REMARKS

Amendments to the Drawings:

Fig. 1

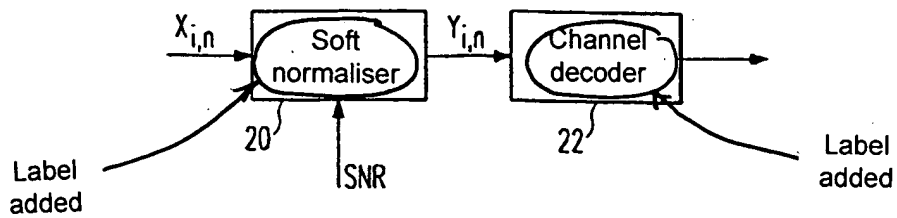
The first sheet, which includes Figures 1-3, replaces the original sheet including Figures 1-3. In Figure 1, elements 20 and 22 have been labeled as “soft normaliser” and “channel decoder”, respectively. In Figure 2, elements 24, 26, 28, and 34 have been labeled as “mean calculator”, “scaling factor”, “truncation”, and “round”, respectively.

Fig. 4
Prior art

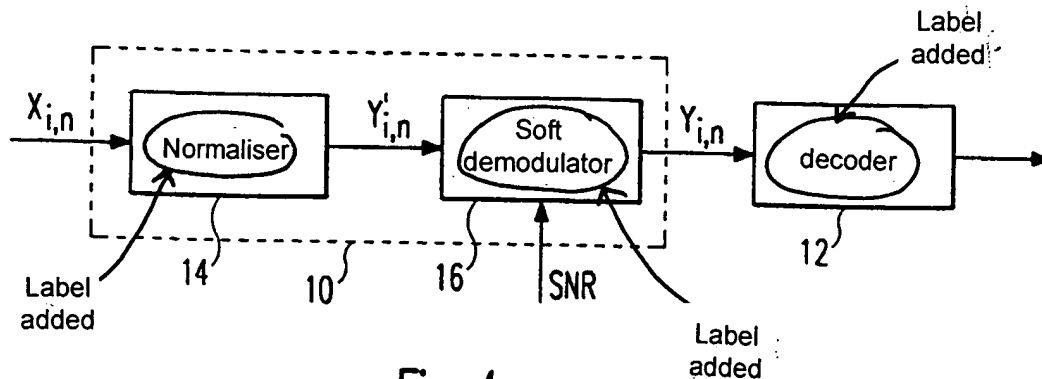
The second sheet, which includes Figure 4, replaces the original sheet including Figure 4. In Figure 4, elements 12, 14, and 16 have been labeled as “decoder”, “normaliser”, and “soft demodulator”, respectively.
